ATTACHMENT 1

PROPOSED McGUIRE UNIT 1 AND 2 TECHNICAL SPECIFICATION CHANGES

ATTACHMENT 2
JUSTIFICATION AND SAFETY ANALYSIS

RELOAD SAFETY EVALUATION

FIGURE (X)

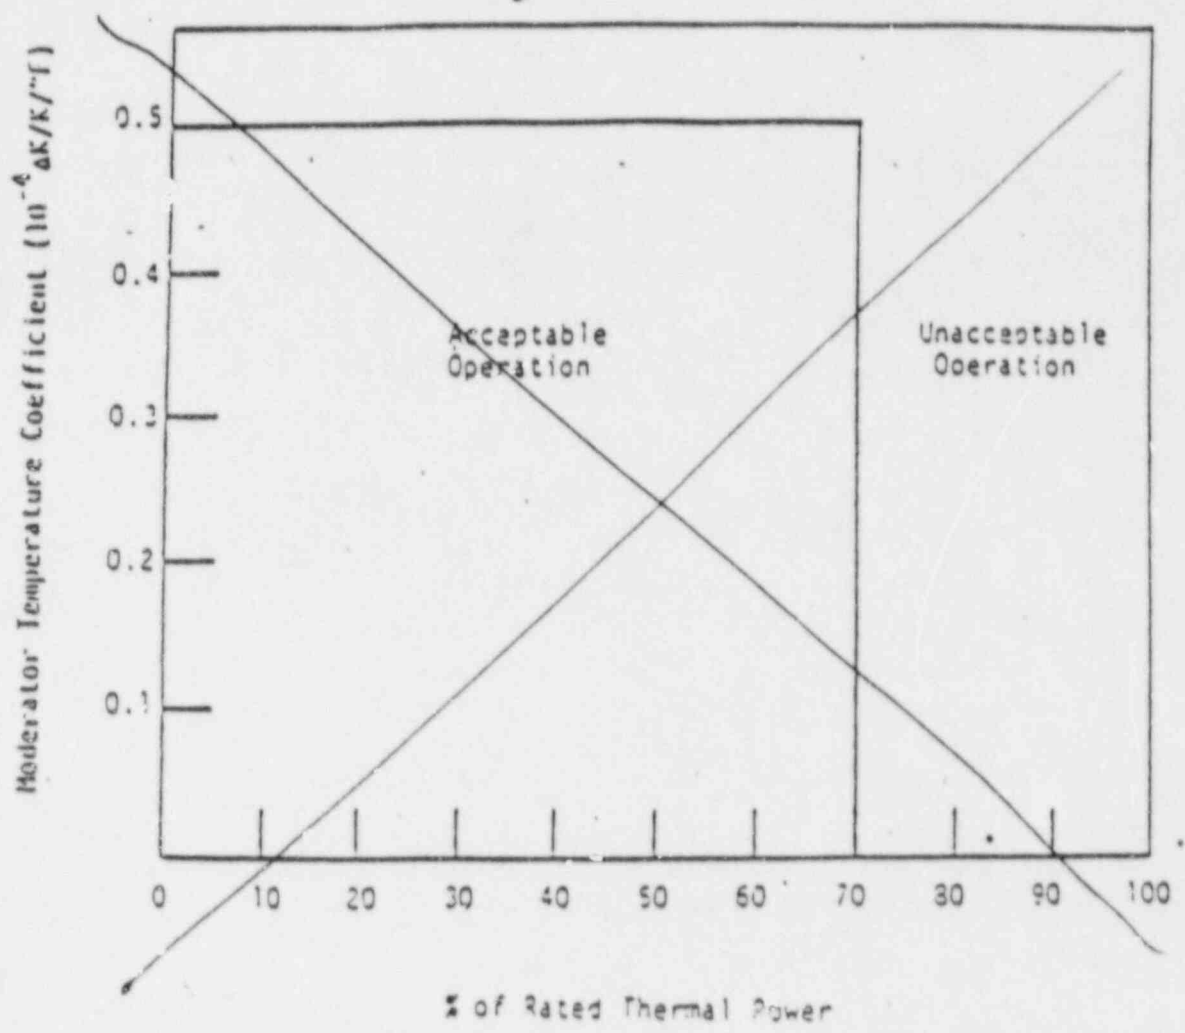
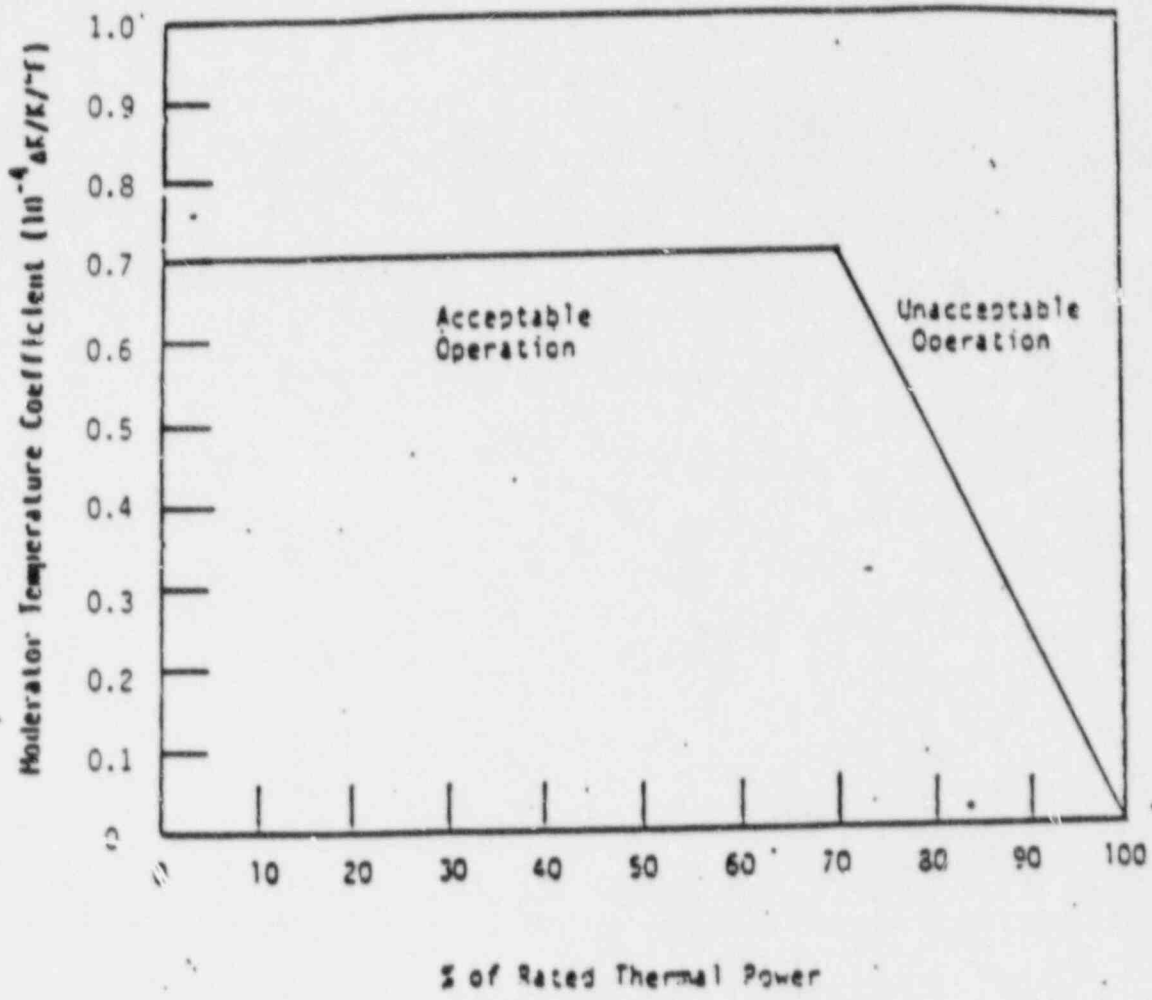
REPLACE WITH THE FOLLOWING
FIGURE (X)

~~FIGURE 3.1-0~~

~~MODERATOR TEMPERATURE COEFFICIENT VS POWER LEVEL~~

FIGURE (Y)

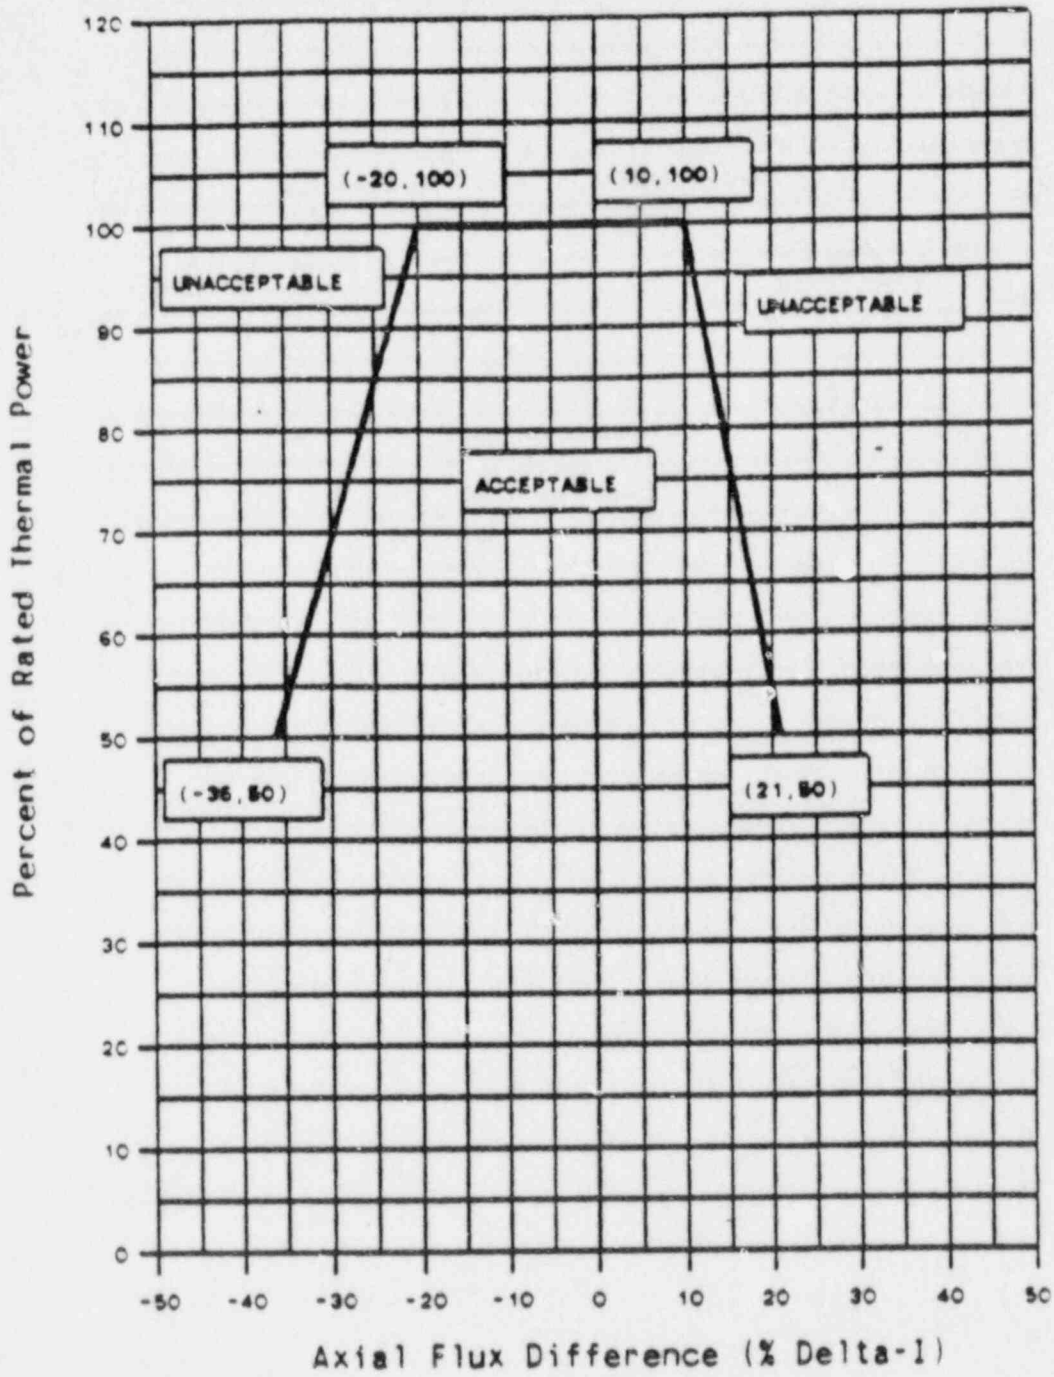
INSERT THE FOLLOWING FIGURE (Y)

~~This page deleted.~~

FIGURE 3.2-1a
AFD Limits as a Function of Rated Thermal Power (UNIT)
~~McGuire Unit 1 Cycle 1~~

FIGURE 3.1-0
 MODERATOR TEMPERATURE COEFFICIENT VS POWER LEVEL

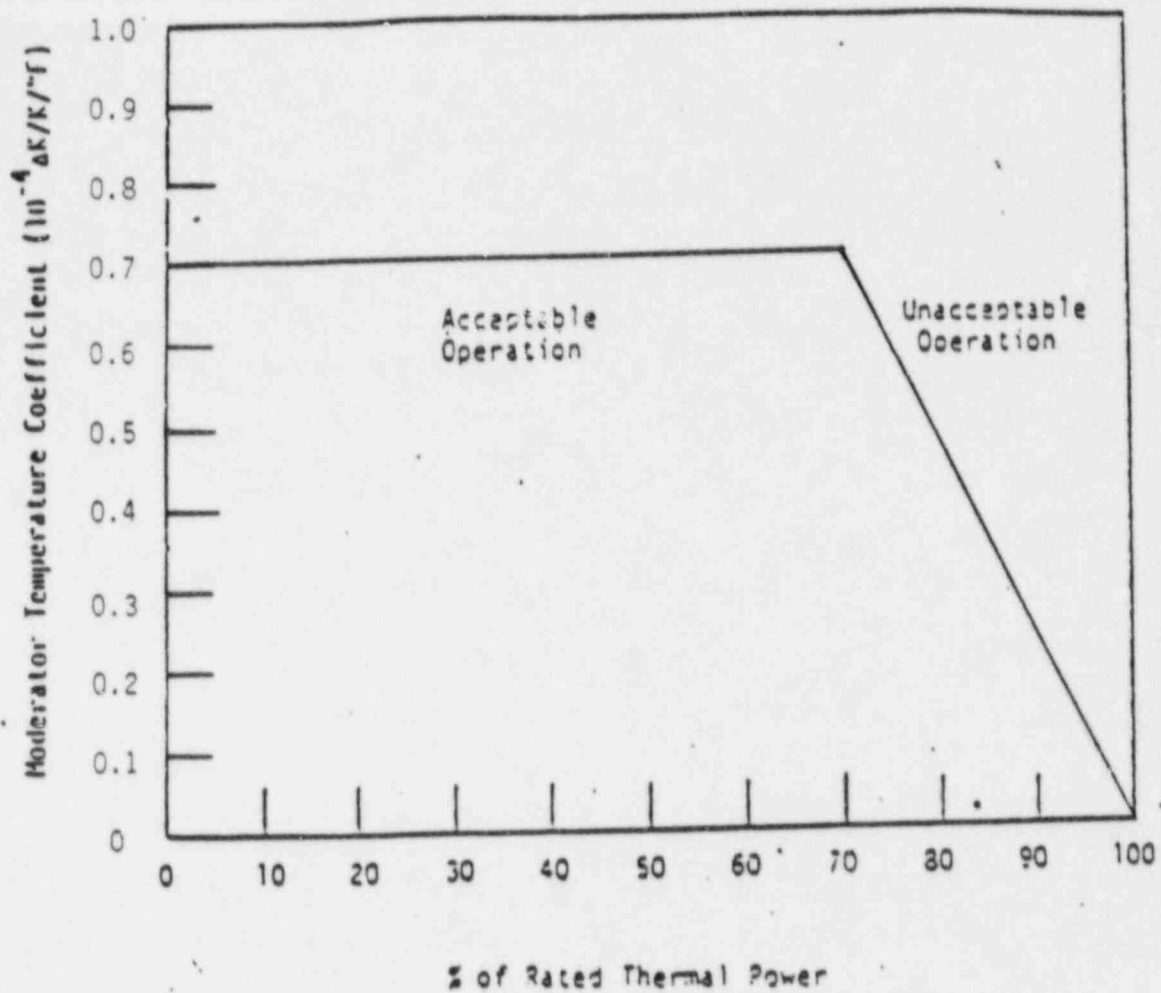
The proposed Technical Specification change would allow a +7 pcm/°F MTC below 70 percent of rated power, ramping down to 0 pcm/°F at 100 percent power. This MTC is diagrammed in Figure 1. A power-level dependent MTC was chosen to minimize the effect of the specification on postulated accidents at high power levels. Moreover, as the power level is raised, the average core water temperature becomes higher as allowed by the programmed average temperature for the plant, tending to bring the moderator coefficient more negative. Also, the boron concentration can be reduced as xenon builds into the core. Thus, there is less need to allow a positive coefficient as full power is approached. As fuel burnup is achieved, boron is further reduced and the moderator coefficient will become negative over the entire operating power range.

FIGURE 3.2-f
 AFD Limits as a Function of Rated Thermal Power
 McGuire Unit 1 Cycle 4

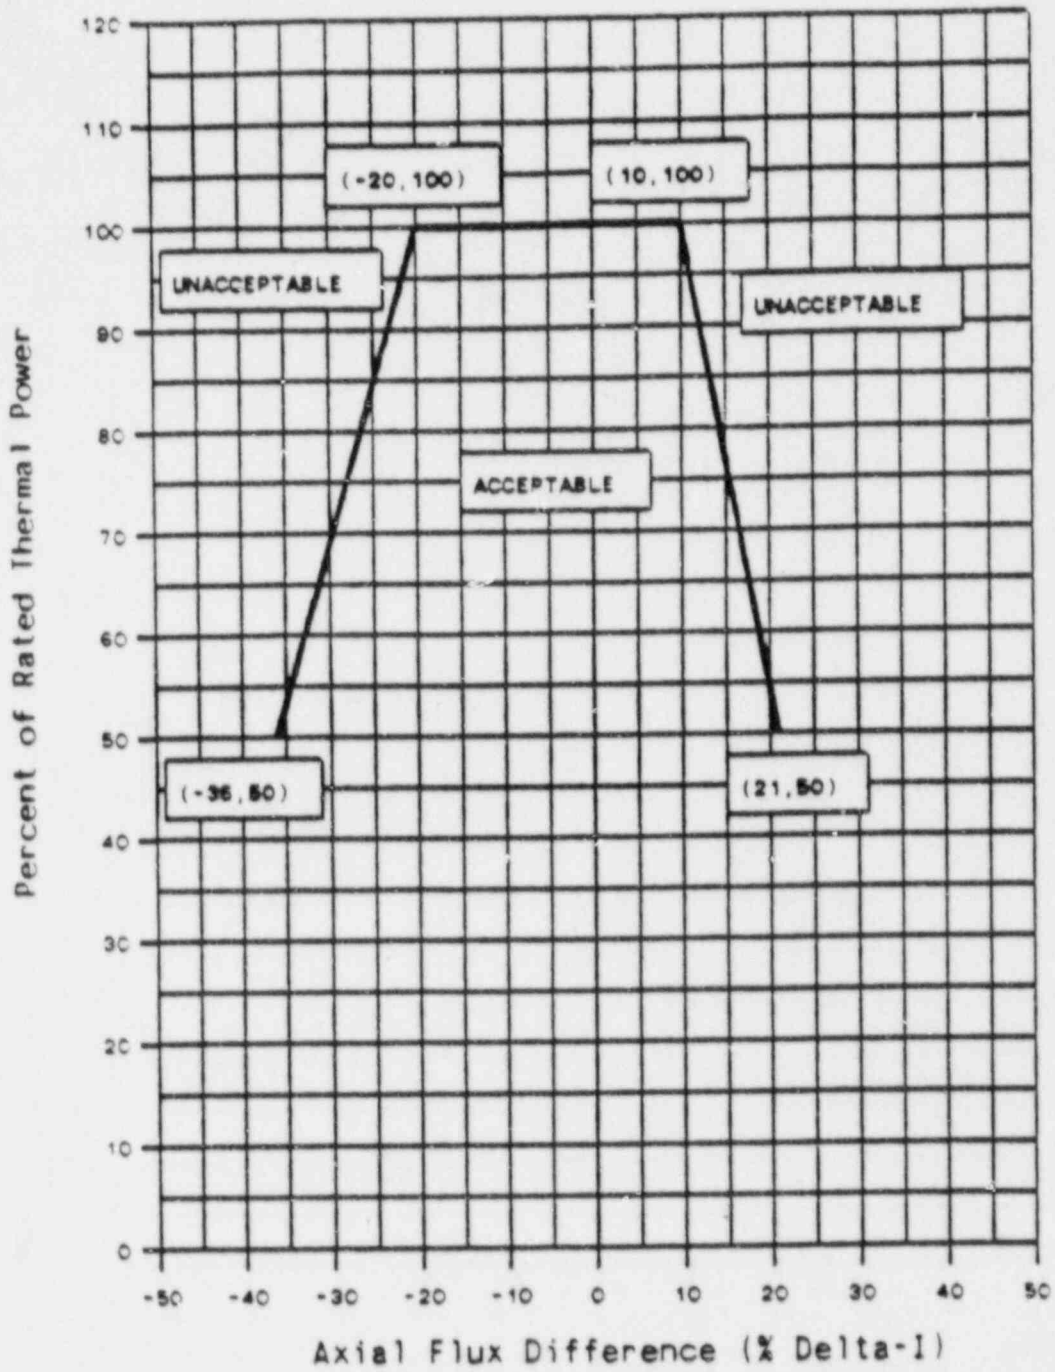
To ensure plant operation consistent with the design and safety evaluation conclusion statements made in the Cycle 4 RSE and to ensure that these conclusions remain valid, Technical Specification changes will be needed for Cycle 4 to incorporate RAOC and a positive moderator temperature coefficient. These changes (presented in Appendix A of the cycle-specific RSE) are discussed in the cycle-specific RSE, along with any necessary justifications. The McGuire Unit 1 Cycle 4 reload design has been performed assuming an increase in the low power beginning of cycle moderator temperature coefficient (MTC) to +7 pcm/degrees F (the MTC technical specification limit is raised to +7 pcm/degrees F up to 70% rated thermal power and ramped to 0 pcm/degrees F at 100% RTP). The unit could startup and operate with the currently approved Technical Specification limit (a "step" of +5 to 0 pcm/degrees F at 70% power) but the probability of entering the action statement requiring interim rod position limits and potential delays in the cycle startup process and a special report to the Commission would be increased. Attachment 2B is the safety evaluation report presenting the evaluations and analyses performed verifying the acceptability of operation of McGuire Unit 1 (and 2) with this increased positive MTC limit of +7 pcm/degrees F, including a description of the proposed change's impact on the FSAR Chapter 15 transients (this report is identified as reference no. 10 in the McGuire Unit 1/Cycle 4 RSE). The McGuire FSAR will be revised accordingly in the appropriate annual FSAR update following approval of this change. The revised Unit 1 RAOC envelope is based upon the F_Q limit of 2.26. The McGuire Unit 1 F_Q limit was increased from 2.15 to 2.26 in submittals associated with the Unit 1/Cycle 3 reload (and for Unit 2 with the Unit 2/Cycle 2 reload). However, the RAOC AFD envelope continued to be based upon the 2.15 F_Q limit until this cycle's RAOC analysis, although the envelope could have been expanded along with the previous limit increase. The revision to the Unit 1 RAOC AFD envelope is simply taking credit for the previously approved higher F_Q limit and brings the nuclear design and LOCA analysis assumption into agreement (Note: Although credit for the 2.26 F_Q limit currently in effect on Unit 2 has not been taken in Unit 2 RAOC analyses performed to date (including the recent Unit 2/Cycle 3 analysis as reflected in the Tucker to Denton letter of February 21, 1986), Duke anticipates similarly expanding
